S-101 Project Team Meeting 9 (S-101PT9)

Wellington - New Zealand - Wed 23rd Nov – Friday 25th Nov 2022

Draft Record

Annex: Consolidated and adjudicated S-101 Main document review comments as finalised at S-101PT9:

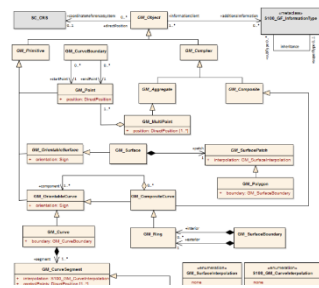
NIWC	4.3.3	2 nd sentence		An information association is not a feature relationship.	There are three types of defined feature relationships in S-101 ...	Agree. Applied.
	NIWC	(Former) 4.3.3.1	Entire	te	Refer to the above. An information association is not a feature relationship.	Move to new clause 4.3.5.1.	Applied. To be confirmed. S-101PT9: Approved.
	DE	4.3.4	Information types	ge		All different kinds of information types should at least be mentioned. -> Contact Details, Service Hours, Non-Standard Working Day, Nautical Information, Spatial quality (see DCEG 24.1 – 24.5)	Have chosen to only include references to the relevant clauses of the DCEG (as for earlier types). Perhaps there is an argument if this is accepted to remove clause 4.3.4.1? To be discussed. S-101PT9: Agreed to reference corresponding clauses in Annex A (DCEG) only.

1	2	(3)	4	5	(6)	(7)	
Component	CO ¹	Clause No./ Subclause No./ Annex (e.g. 3.1)	Paragraph/ Figure/ Table/ Note (e.g. Table 1)	Type of comment ²	Comment (justification for change) by the CO ³	Proposed change by the CO	Secretariat observations on each comment submitted
	NIWC	4.3.4.1	1 st para			Delete everything after 1 st sentence in this paragraph.	To be discussed in association with other comments for this clause. S-101PT9: Agreed to reference corresponding clauses in Annex A (DCEG) only. Figure removed.
	DE	4.3.4.1	Figure 4-5	te	See DCEG 24.5	qualityOfHorizontalMeasurement: only values 4 and 5 are allowed	Agree – needs to be updated. However, as for above comment, does this need to be in 2 places? Suggest remove this clause altogether. To be discussed. S-101PT9: Figure removed. See above.
	NIWC	4.3.4.1	Figure 4-5	te	This is inaccurate: <ul style="list-style-type: none"> The modelling of SpatialQuality has changed: <ul style="list-style-type: none"> add <i>spatialAccuracy</i> QoBD may have an association to SpatialQuality through QoBDComposition The relationships shown here are simplifications of those described in S-100 5.0.0 Figure 7-3 Geometry: 		IHO Sec: To be discussed in association with other comments for this clause. However, if this revised UML diagram is correct, suggest that it replace the current DCEG Figure 2.1. S-101PT9: Figure removed. See above.

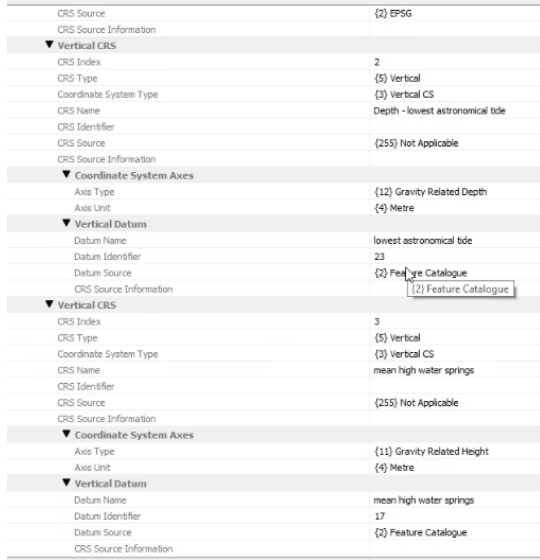
7Cs	4.7.2	Figure 4-9	te	Condition: maximumDisplayScale <= MSVS <= minimumDisplayScale	In clause 4.6: Twice maxDS, twice min.DS	Agree. To be discussed. S-101PT9: Change not yet applied. S-100WG7: Clause restructured.
	7Cs	4.7.2	Figure 4-9	ed	Minimum displayScale	minimumDisplayScale	Agree: To be applied. S-101PT9: Change not yet applied. S-100WG7: Clause restructured.
	DE	4.7.2	Fig. 4-9	ed	The original Fig. 4-9 is very confusing as it does not match the methods described in 4.7.1 and 4.7.2 (maybe due to the above mentioned issues).	Replace Fig. 4-9 with proposed alternative figure/table: Alternative_Figures_DEproposal.docx (follows this Table)	See proposed replacement Figure (table) below. To be discussed. S-101PT9: Change not yet applied. S-100WG7: Clause restructured.
	7Cs	4.7.2	Figure 4-10	ed		- Why X, Y, Z and 1, 2, 3? - Use always same size for numbers	Consider all Figures in this clause need review so as to
